Form 3160-5
(June 2015)UNITED STATES
DEPARTMENT OF THE INTERIOR
BUREAU OF LAND MANAGEMENTFORM APPROVED
OMB No. 1004-0137
Expires: January 31, 2018**SUNDRY NOTICES AND REPORTS ON WELLS**
Do not use this form for proposals to drill or to re-enter an abandoned well. Use Form 3160-3 (APD) for such proposals.5. Lease Serial No. **NMNM-0177517**

NMNM-82050X8. Well Name and No. **CATO SAN ANDRES UNIT #110**9. API Well No. **30-005-20015**4. Location of Well (Footage, Sec., T., R., M., or Survey Description)
1980 FSL, 660 FWL, UNIT L, SEC 14, T8S R30E10. Field and Pool or Exploratory Area
CATO; SAN ANDRES11. Country or Parish, State
CHAVES**12. CHECK THE APPROPRIATE BOX(ES) TO INDICATE NATURE OF NOTICE, REPORT OR OTHER DATA**

Notice of Intent to PA- Procedure

**Cato San Andres Unit 110
30-005-20015
Oxy USA Incorporated
October 24, 2022
Conditions of Approval**

Proposed**Cato San Andreas Unit # 110****API # 3000520015****Surf Lat 33.61793
Surf Long -103.85624**

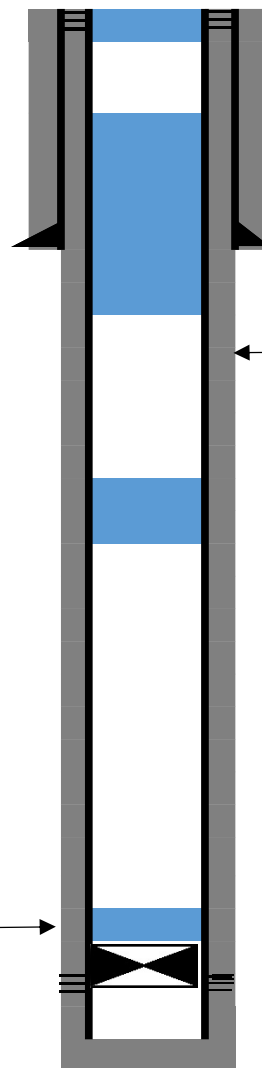
- 1. Operator shall place CIBP at 3,462' (50'-100' above top most perf) and place a minimum of 25 sx of Class C cement on top. WOC and TAG.**
- 2. Operator shall place a balanced Class C cement plug from 1,670' to 1,090' to seal the Yates and Salt formations. WOC and TAG.**
- 3. Operator shall perf at 500' and squeeze class c cement to surface to seal the 8-5/8" casing shoe.**
- 4. Dry hole marker must be below ground.**
- 5. Surface reclamation will need to be completed once the well bore has been plugged. Please contact rflores@blm.gov for additional information.**
- 6. See Attached for general plugging stipulations.**
